Detailed Site Plan Dunkin Donuts Clinton

DSP-20018

STAFF REPORT

SUBJECT: Detailed Site Plan DSP-20018
Dunkin Donuts Clinton

A1 Building Elevations

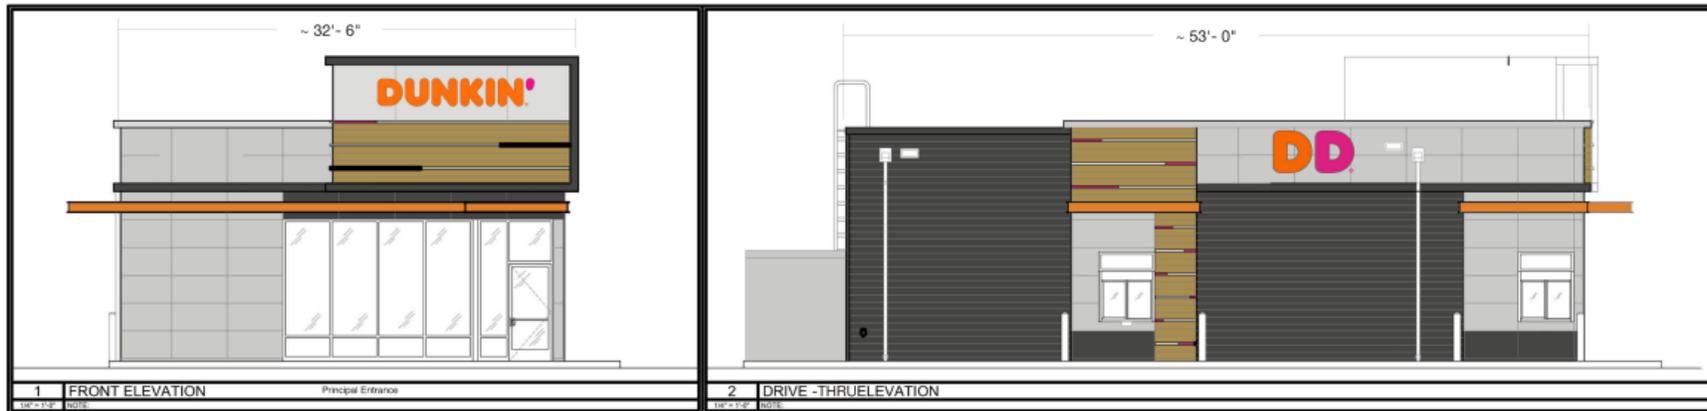
- h. Correct the Zoning Ordinance Sign Sizing Note on Sheet 1 to reflect the freestanding sign height and area proposed.
- i. Provide a signage area table demonstrating how the building-mounted and freestanding signs conform to Sections 27-613 and 27-614 of the Prince George's County Zoning Ordinance.
- j. Provide the height of the sign proposed above the roof line to demonstrate that it is in conformance with Section 27-613(b)(1) of the Prince George's County Zoning Ordinance.
- k. Provide all the signage dimensions and measurements in decimal values to maintain consistency in the DSP.

6. Building and freestanding sign tables shall be provided to better demonstrate conformance to the sign design standards of the Zoning Ordinance.
7. The total proposed building sign areas exceeds the total sign area allowed, per Sec. 27-613(c)(3)(c). Adjustment to the signs shall be demonstrated. Demonstrate compliance in sign table accordingly and revise sign details as necessary.

8. On building elevation sheet(s) of sign package, the height of the sign above the roof line or parapet wall shall be demonstrated to show the sign does not extend more than twelve (12) feet above that part of the building to which the sign is attached, per Sec. 27-613(b)(1).
